Access Compliance Report

Public Rights-of-Way

Intersection ID: 14217	Main Street: KENHILL_DR	Cross Street: WEST_BV	Location: NE
ADA ID: 4B8C1A5DDDE5	Ramp Type: Combination1Diag	Initial Pass/Fail: Fail	Overall Compliance: No
Severity Score: 0			
Codes/Mitigation Info/Possible Solution		Field Measurements/Component Compliance

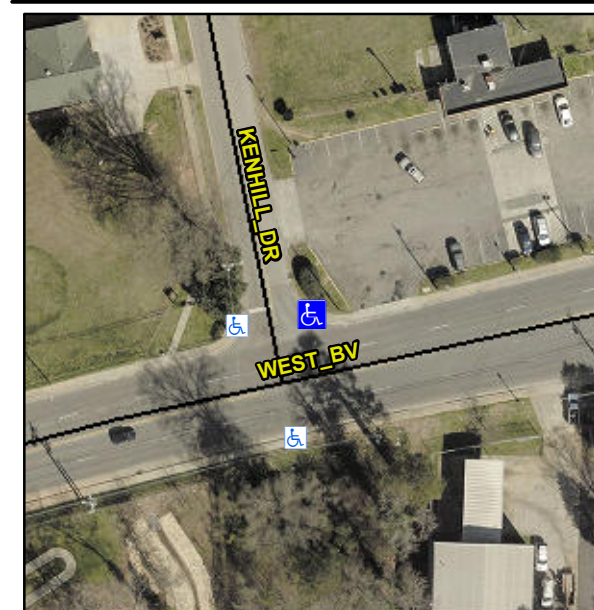
Not Found, R304.5.1, R304.5.3

Compliance	Description	Data	Compliance	Description	Data
N/A	Ramp Length LT (in)	55.0	N/A	Ramp Length RT (in)	56.0
Yes	Ramp Width LT (in)	48.0	Yes	Ramp Width RT (in)	48.0
Yes	Ramp Slope LT (%)	5.8	Yes	Ramp Slope RT (%)	6.5
No	Ramp XSlope LT (%)	6.0	No	Ramp XSlope RT (%)	5.7
N/A	Ramp Length (in)	42.0	Yes	Ramp Slope (%)	5.4
No	Ramp Width (in)	44.0	Yes	Ramp XSlope (%)	0.5
N/A	Flare Type LT	N/A	N/A	Flare Type RT	N/A
N/A	Flare Slope LT (%)	N/A	N/A	Flare Slope RT (%)	N/A
N/A	Flare Traversable LT?	N/A	N/A	Flare Traversable RT?	N/A
N/A	Landing Length (in)	N/A	N/A	DWS Provided?	N/A
N/A	Landing Width (in)	N/A	N/A	DWS Contrast?	N/A
N/A	Landing Slope (%)	N/A	N/A	DWS Length (in)	N/A
N/A	Landing X Slope (%)	N/A	N/A	DWS Full Width?	N/A
N/A	Landing Curb? (Y/N)	N/A	N/A	DWS Offset (in)	N/A
N/A	Shared Landing?	N/A			
N/A	Gutter Ponding?	N/A	N/A	Gutter Slope (%)	N/A
N/A	Gutter Lip Ht (in)	N/A	N/A	Gutter X Slope (%)	N/A
N/A	Painted X Walk1?	No	N/A	Painted X Walk2?	No

Remove & Replace Curb Ramp With Two New Directional Ramps or Equivalent.
